Service Provider Letter

Jurisdiction:	<u>City of Tualatin</u>	Review Type:	<u>Tier 2 Analysis</u>
Site Address / Location:	<u>19000 SW 124th AVE</u> <u>Tualatin, OR 97062</u>	SPL Issue Date:	<u>January 31, 2023</u>
		SPL Expiration Date:	<u>January 30, 2025</u>

Existing Conditions Map SW 124th Avenue Tualatin, Oregon

Applicant Name: VLMK - Jennifer Kimura
Address: 3933 S Kelly Ave Portland, Oregon 97239
Phone: 971.254.8300
Email: jenniferk@vlmk.com
Site Address: 19000 SW 124th Ave & 12075 SW TS Rd
City: Tualatin, Oregon 97062
Map & Tax Lot #: 2S127BB00100 2S127BB00200
Business Name: 124th Ave Business Park
Land Use/Building Jurisdiction: City of Tualatin
Land Use/ Building Permit # AR23-0004/PLA23-0003

FS-2

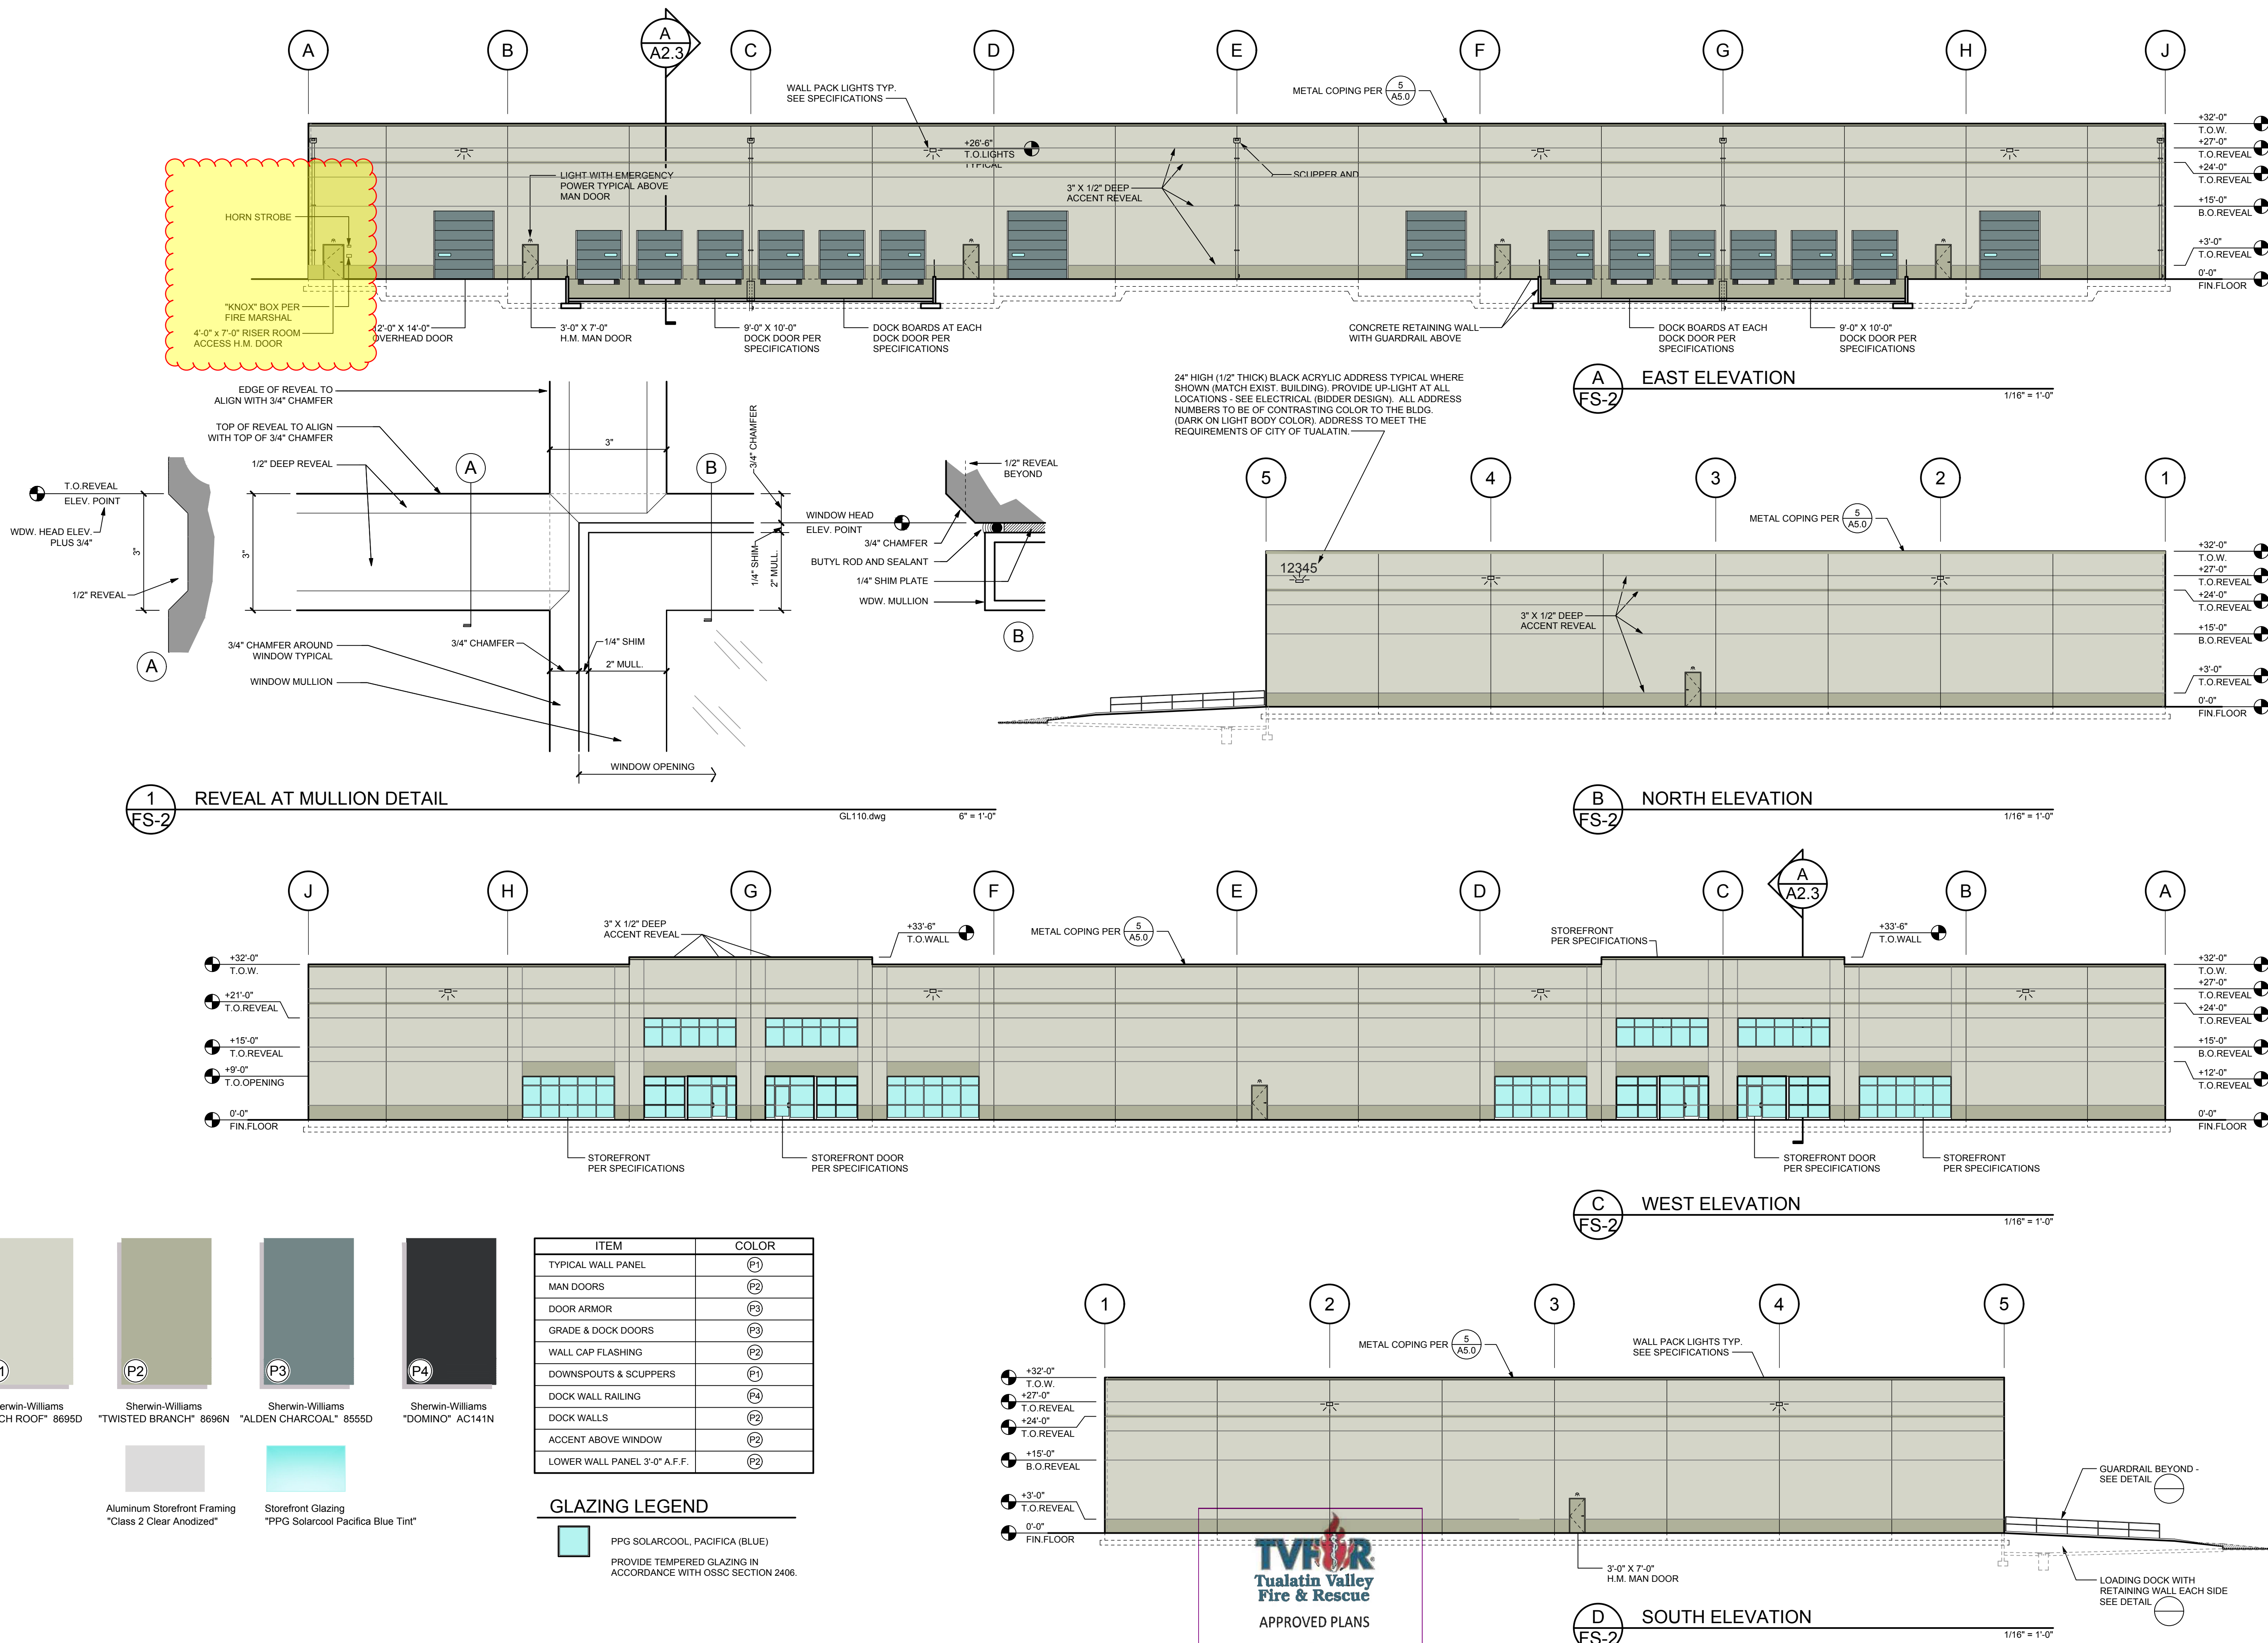
Conditions: TVF&R final inspection required.

MERRC declined in favor of ERRC system.
